ATTACHMENT 1

PROPOSED TECHNICAL SPECIFICATIONS CHANGES

NORTH ANNA UNITS 1 AND 2

ATTACHMENT 2
DISCUSSION AND SAFETY EVALUATION

FIGURE 1
 17 X 17 NAIF / LOPAR
 FUEL ASSEMBLY COMPARISON

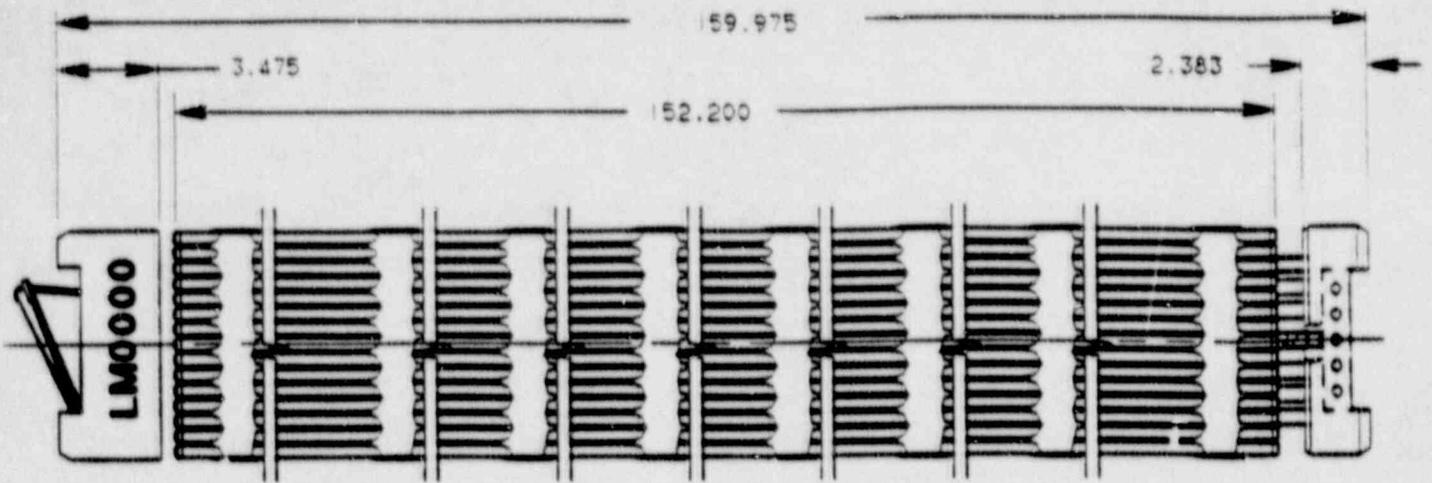
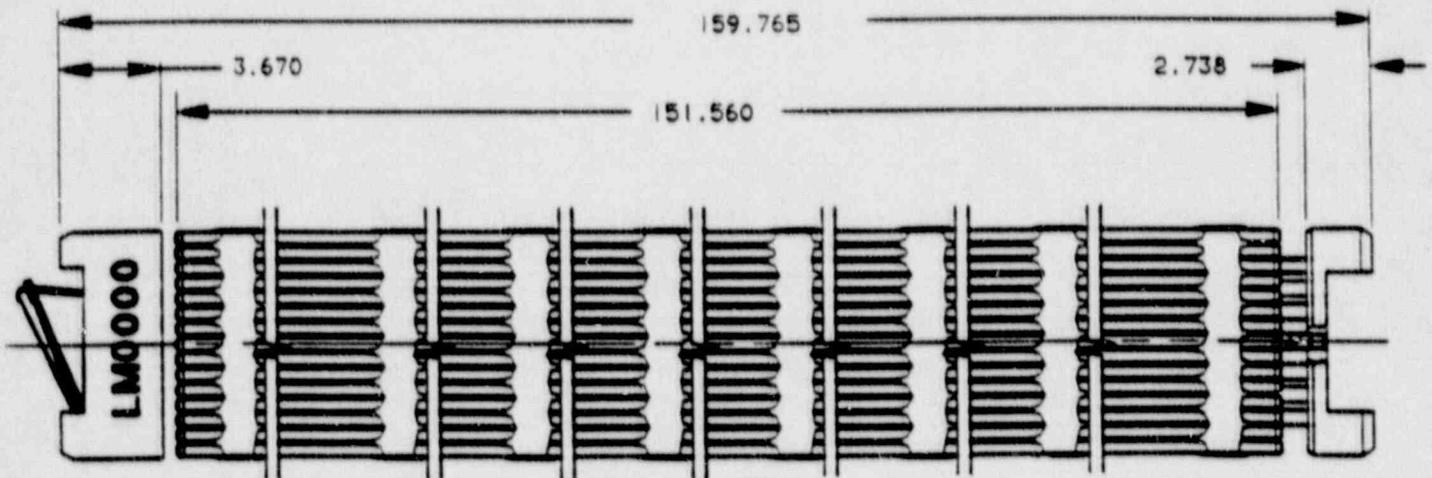
The NAIF assemblies have been designed to be compatible with the LOPAR assemblies, reactor internals interfaces, and fuel handling and refueling equipment. Figure 1 gives a side-by-side comparison of the fuel assemblies. The grid elevations for the two assembly designs are nearly the same such that any integral contact between the assemblies will be grid-to-grid. By matching grid elevations, any crossflow maldistribution between the LOPAR and NAIF fuel assembly is minimized. The assembly envelopes and fuel rod diameters are the same. In addition the top and bottom grids in both designs are Inconel. Changes from the LOPAR to the NAIF assembly design include: decreases in guide thimble and instrumentation tube diametral dimensions, the change from use of the six intermediate LOPAR Inconel grids to a VANTAGE 5H Zircaloy grid design, the change to the VANTAGE 5H removable top nozzle (RTN) with modified holddown spring, the change to a low profile debris filtering bottom nozzle (DFBN), and the change to the longer VANTAGE 5H fuel rod and fuel assembly structure.

The 17x17 NAIF (VANTAGE 5H) assembly guide thimbles are similar in design to their counterparts in the LOPAR fuel assemblies except for a 8 mil ID and OD reduction above the dashpot and an decreased length due to the removable top nozzle. The diameter reduction is due to a reduced grid cell. This results from use of thicker grid strap material for the Zircaloy grids. Below the dashpot the NAIF and LOPAR assembly guide thimble dimensions are identical. The VANTAGE 5H guide thimble tube ID continues to provide an adequate nominal diametral clearance for the control rods and other core components. However, due to the reduced clearance, the time to the dashpot for accident analyses has conservatively been determined to increase from 2.2 seconds (to dashpot) for the LOPAR assemblies to 2.7 seconds for the NAIF assemblies. The increase in rod drop time required accident reanalyses as described in Section 6.0 of this report.

- 1) The DFBN uses a modified pattern with a smaller flow hole size. The holes are sized to minimize the passage of debris through the nozzle.
- 2) The DFBN uses a decreased nozzle height and thinner plate to accommodate the extended burnup fuel rod.
- 3) Skirts are added to the bottom periphery of the plate between the legs to strengthen the plate and legs (see Figure 1).
